Subject: **ADDENDUM No. 3, RFT 2025-011**

Novar Covered Rink

SK-1

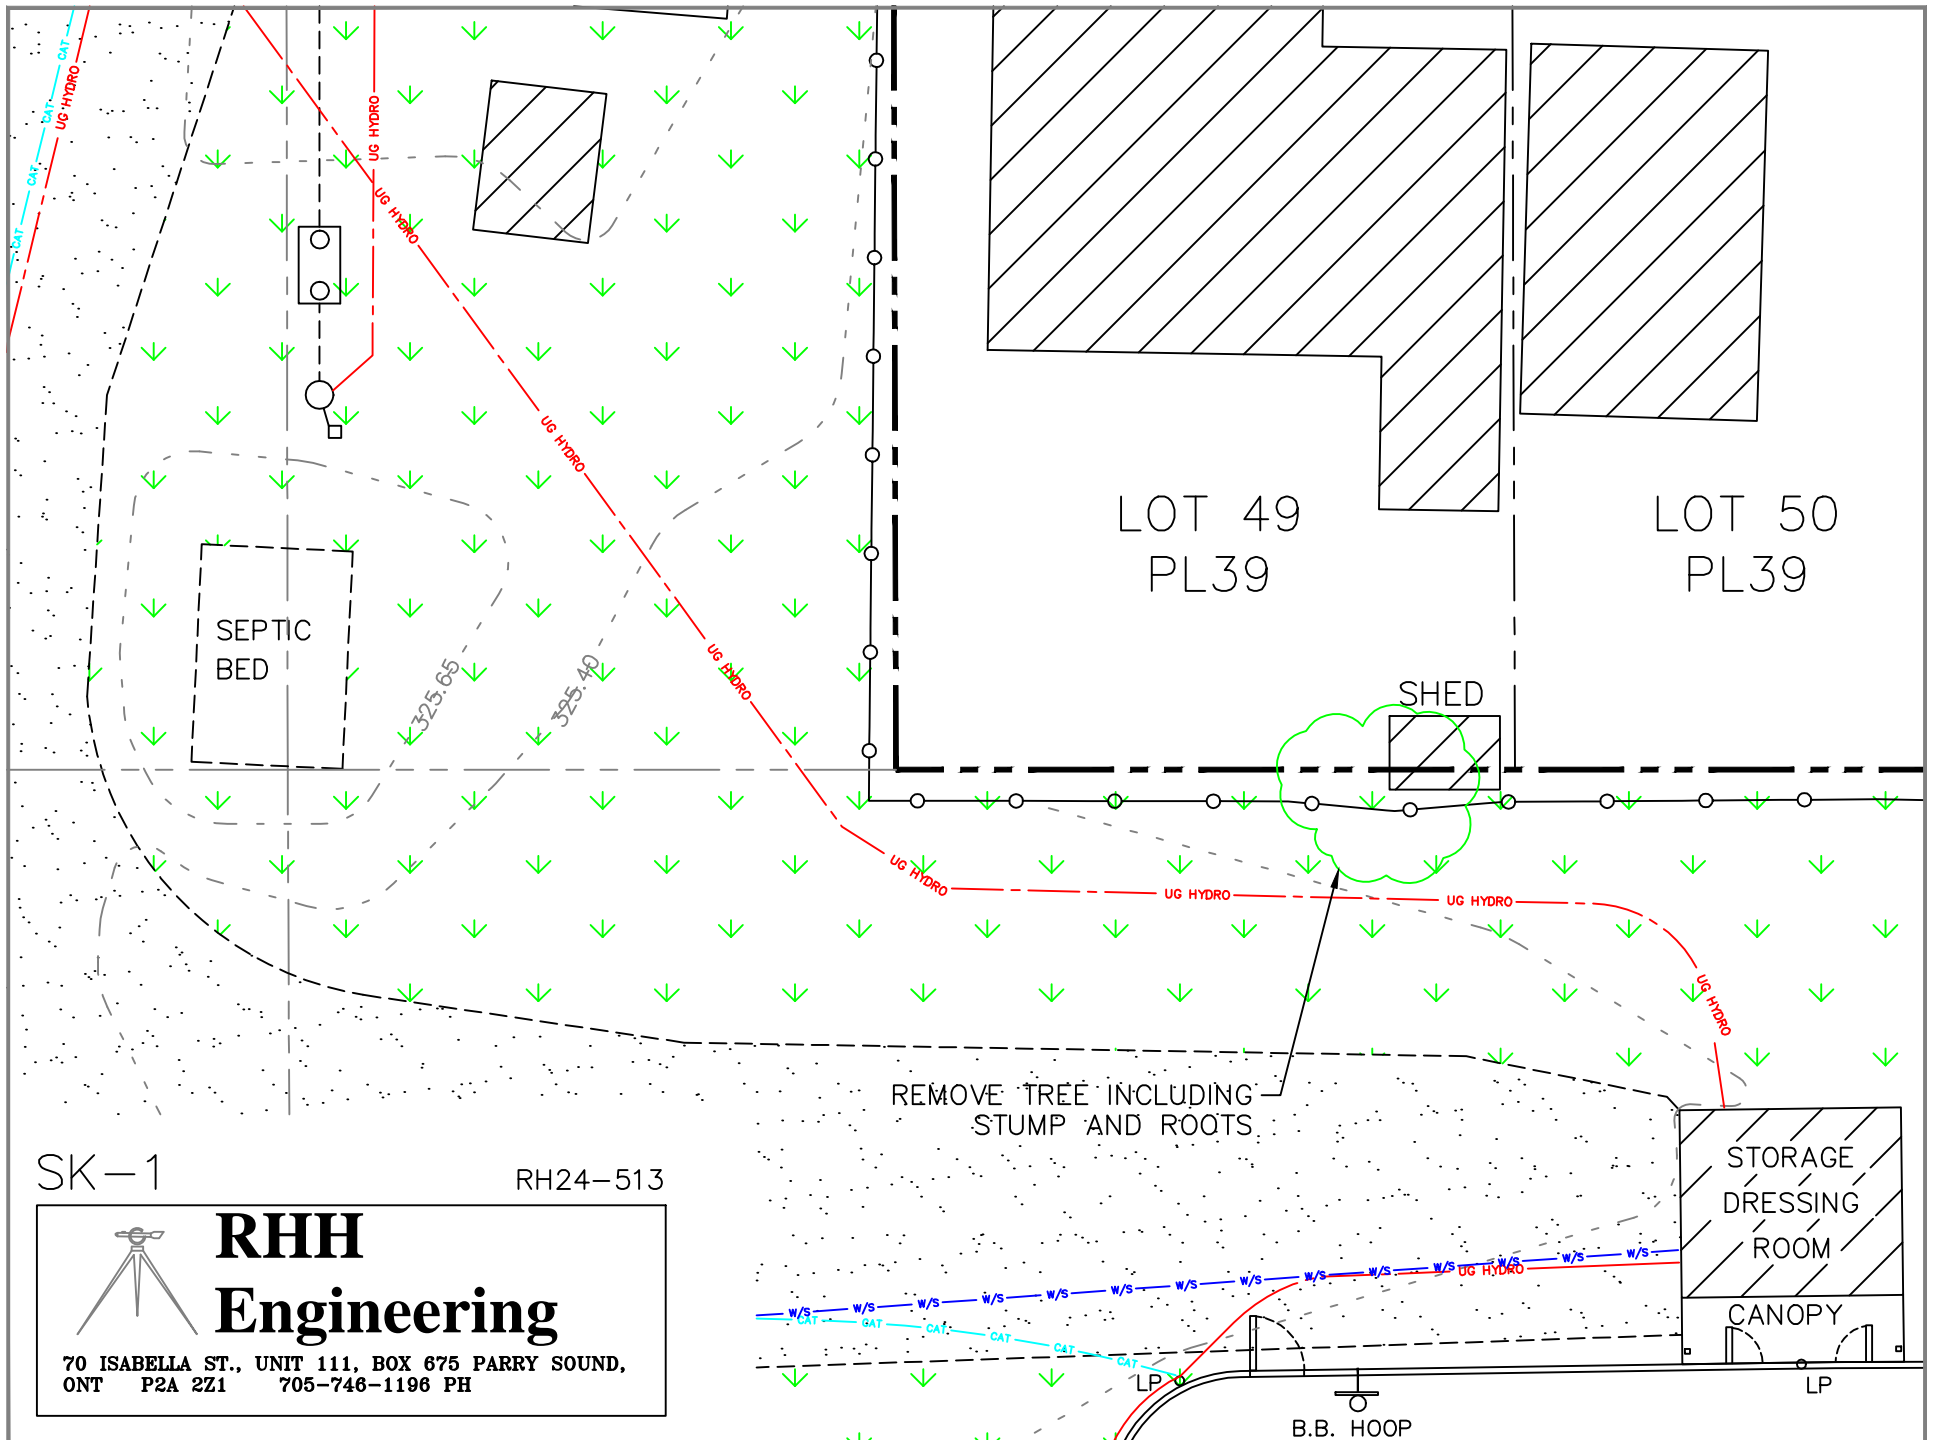
5. *Does the Hydro scope go up to and include the new transformer? If not, where does it end?*

The Contractor shall install the underground duct bank (to ESA specifications) and wiring from the hydro pole (new) at the street to the transformer location as shown on SP-2. The Contractor shall leave approximately 12 metres of wire at the street pole for Hydro One to run up the pole and make the connection. Additionally, the Contractor shall supply and install the transformer vault and leave approximately 5 metres of wire at the transformer for Hydro One to make the connection. The Contractor is responsible for all electrical installation from the transformer to the building.

SK-2

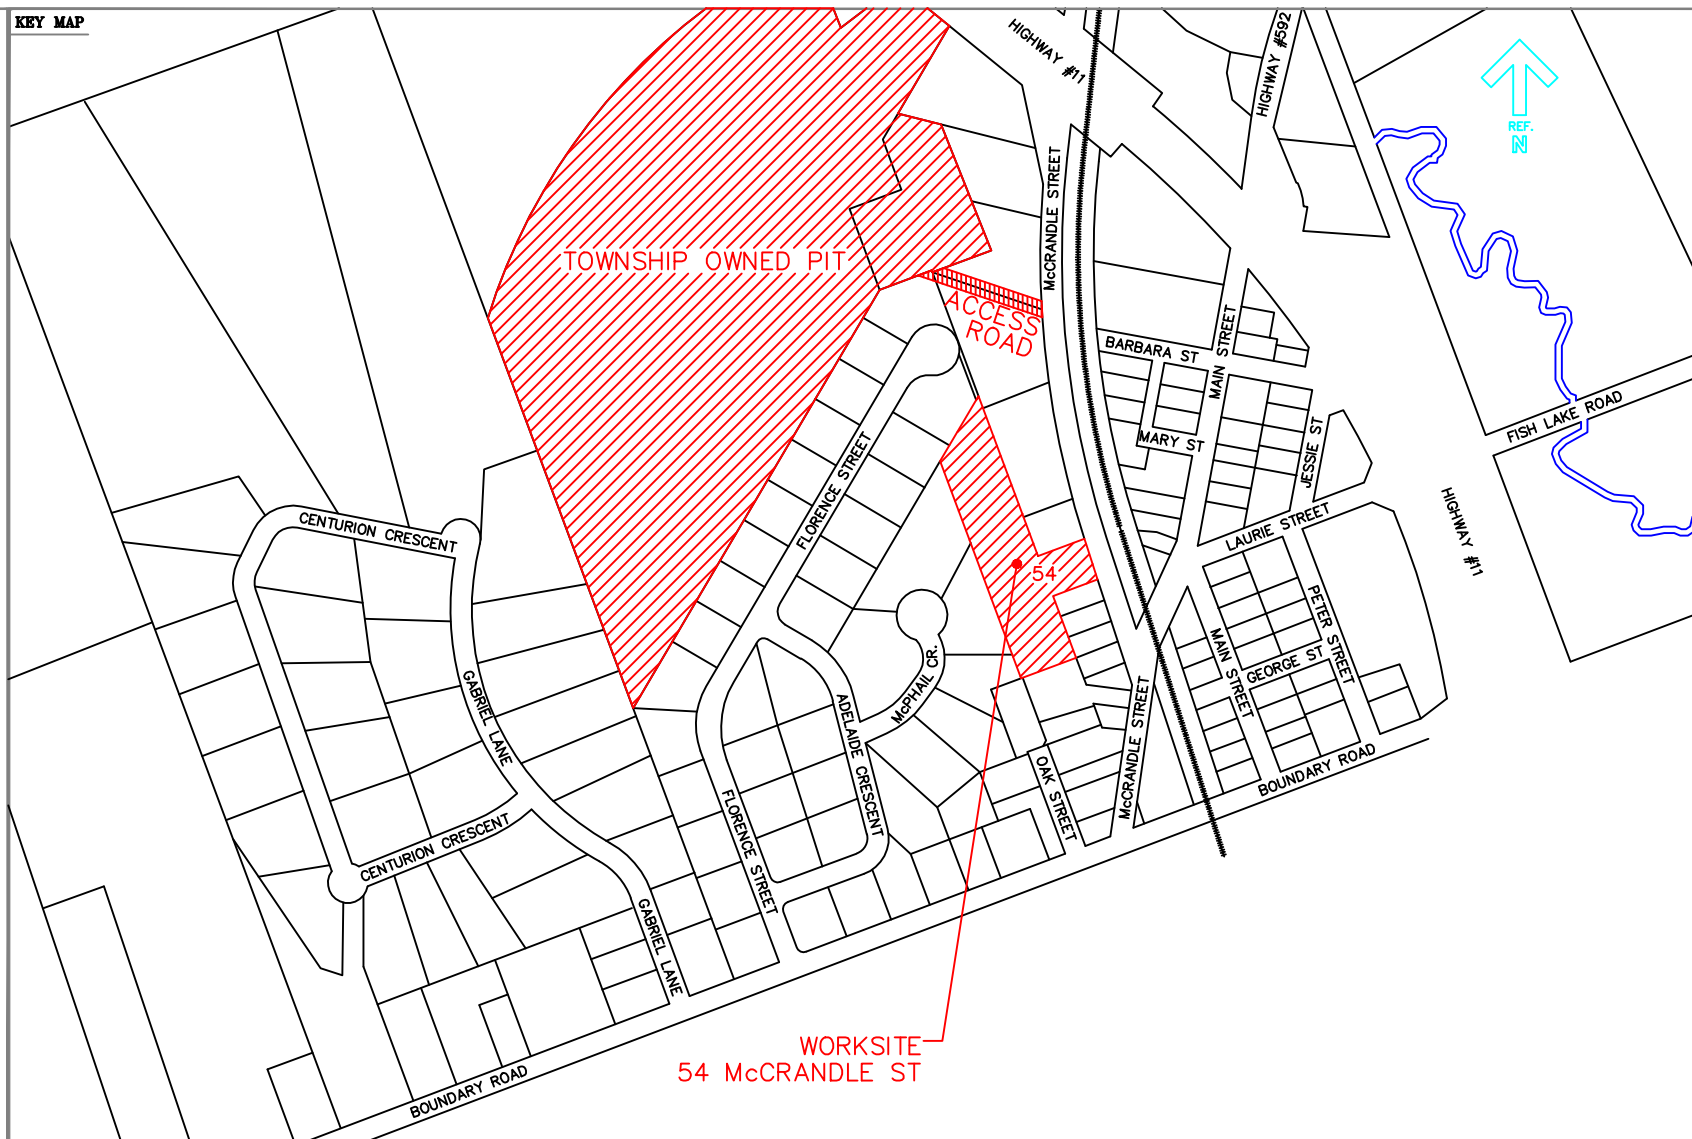
10. *Is there a site for disposing of surplus earth/granular materials.*

The Township has an old pit located a short distance off of McCrandle St. as shown on site diagram SK-2. Clean fill can be disposed of (not asphalt or building materials).
